Indirect Measurement Summary

Little Missouri River at Albert Pike, Arkansas

Flood of June 11, 2010

Type of measurement: Slope Area

Cross Section X1

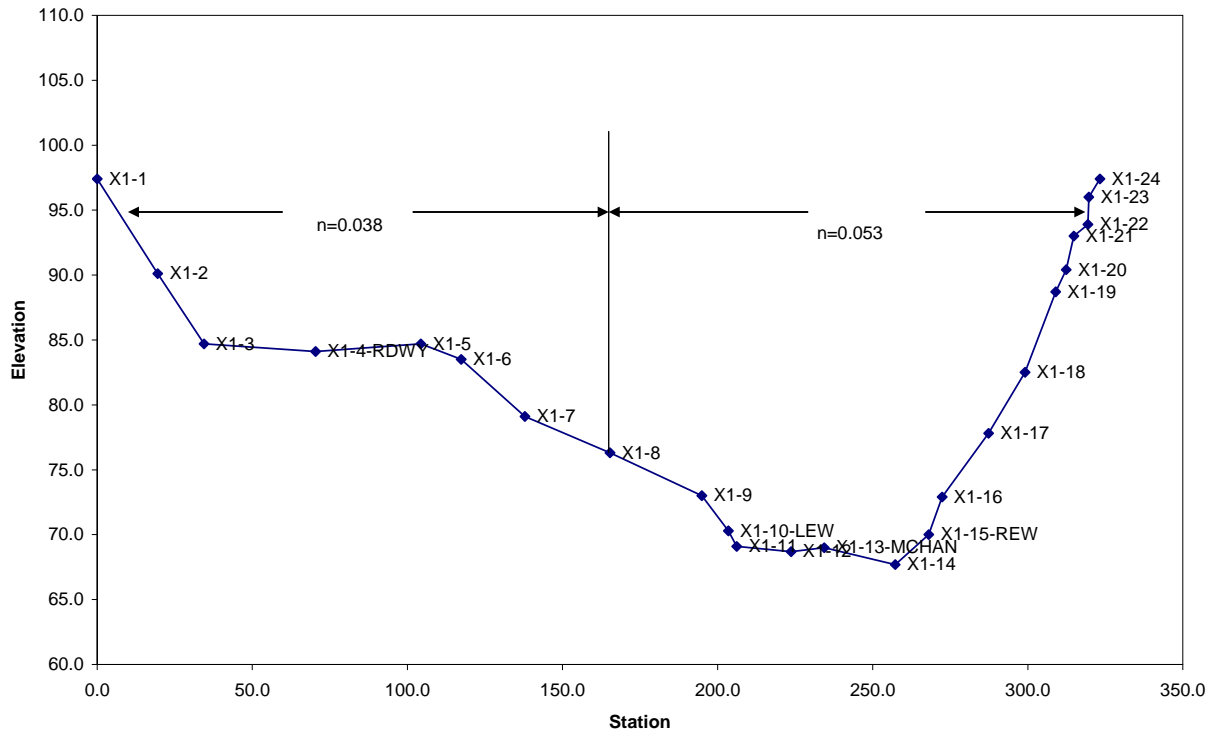
3. Subarea break between the left overbank and main channel is at 165.3 stationing for cross section 1 (X1). Geometry data for this cross section and comparison to X2 and X3 the subarea break would be more representative at station 137.9. Perhaps a subarea break even at station 156.5 would be suitable depending on slope area output results.
Subarea break point was located to coincide with a boundary roughness change. Mark Smith re-computed the indirect with the same suggested subdivision of X1, with the result that it only changed the discharge by less than -0.8%. No changes to the subarea break point was made.
